SUBJECT: Savannah River Site's Responses to the Regulatory Comments on the Decommissioning Project Final Report for Building 454-D, D-Area Diesel Fuel Tank (V-PCOR-D-00048, Revision 0, July 14, 2022)

**SRS RESPONSES TO
EPA COMMENTS ON THE
DECOMMISSIONING PROJECT FINAL REPORT
BUILDING 454-D, D-AREA DIESEL FUEL TANK, REVISION 0
JULY 2022**

Figure 4. Building 454-D Slab and Sump (Looking West) Before

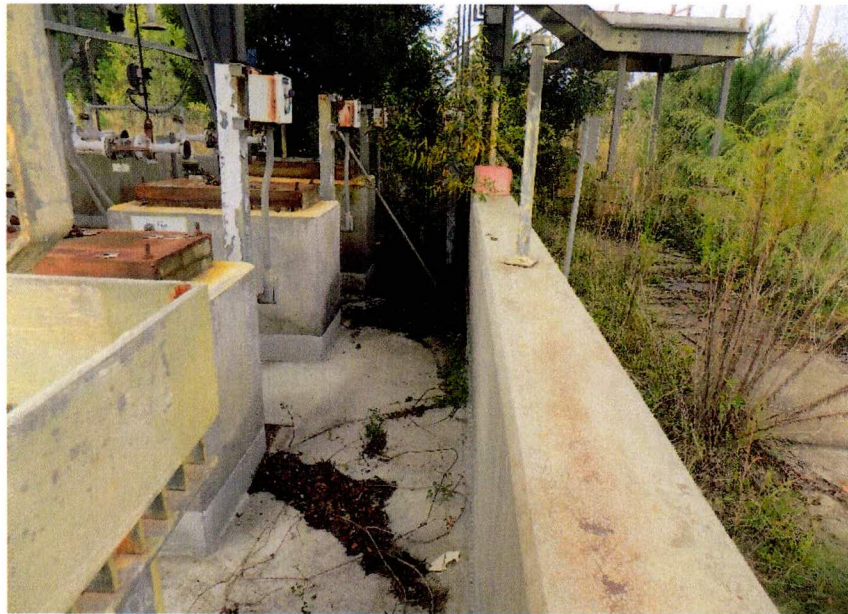
2. The DPFR indicates in Section 1.0 (Summary) that all interfacing utilities were isolated, disconnected, and plugged, and the resulting holes were grouted; however, photographs depicting the plugged and grouted holes are not provided in Appendix A (Before and After Photos of the Facility/Structure). In addition, photographs depicting a view of the slab condition of Building 454-D before and after decommissioning were not included in the

DPFR. Please revise the DPFR to include photographs of the plugged and grouted holes and a view of the Building 454-D slab condition before and after decommissioning.

Figures 1 to 12 below provide photos of the 454-D and 454-1D slabs and sumps before and after decommissioning. The concrete slabs were verified to be free of equipment, structure, rubble, waste, and debris. All interfacing utilities were isolated, disconnected, and plugged. Resulting holes were plugged and grouted. The 454-D and 454-1D sumps were filled with gravel. The 454-D containment dike walls were breached in the northwest corner to prevent rainwater accumulation. There are no holes present in the slabs that would provide access to the environmental media beneath them. These decommissioning activities and the end-state condition of the concrete slabs and sumps are described in Sections 1.0, 4.0, and 6.0 of the DPFR. Future reports will include photos that clearly show the condition of the facilities before and after decommissioning. No change to the document is proposed.
